RE: Oxley Solar Farm (SSD-10346) Armidale Regional Council

Enclosure: Attachment 1: Detailed BCD Comments - Oxley Solar Farm (SSD-10346)

Attachment 1: Detailed BCD Comments – Oxley Solar Farm (SSD-10346)

Biodiversity Development Assessment Report

Figure 7-1 of the BDAR shows the mapped indirect impact area of the proposal as shown shaded pink below.

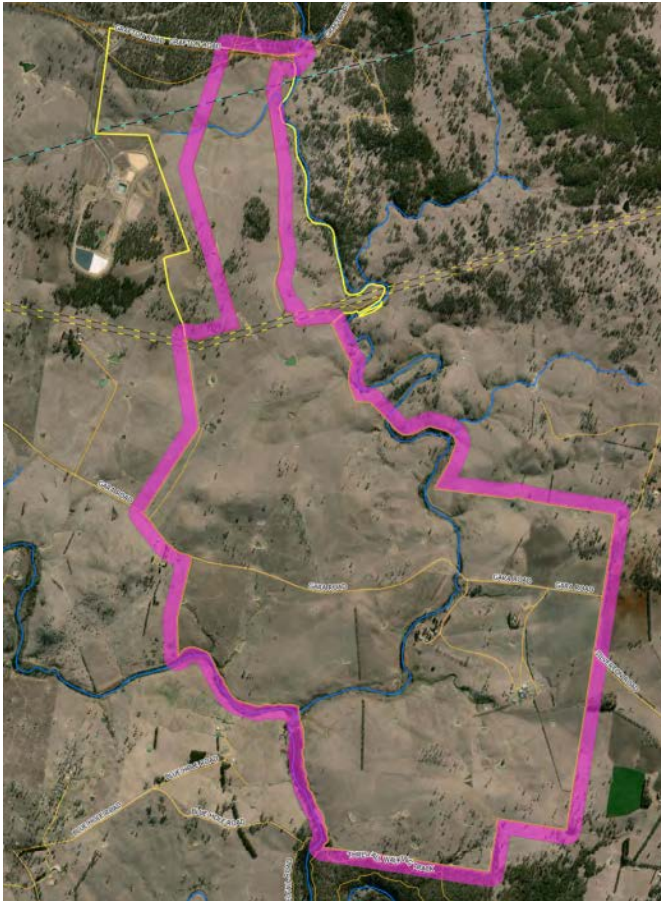
Table 7-5 of the BDAR describes the types of indirect impacts that may occur from the development. Some of these indirect impacts may extend to outside the subject site, however the main consideration of the indirect impact zone should be focused to the area immediately adjacent to the development footprint, such as solar arrays, access tracks and other infrastructure.

All direct impacts of the proposal are shown in figure 1-3 of the BDAR, which identifies the development footprint. An indirect impact zone should be identified around the development footprint.

We note that mitigation measures have been identified in section 8 of the BDAR to address any potential indirect impacts. If the BDAR cannot demonstrate that all indirect impacts have been effectively mitigated, then biodiversity credits should be calculated for the remaining indirect impacts in accordance with the BAM Operational Manual Stage 2.

4. Further consideration must be given in the BDAR to identifying indirect impacts immediately adjacent to the development footprint and determining whether biodiversity credits are required to offset these impacts.
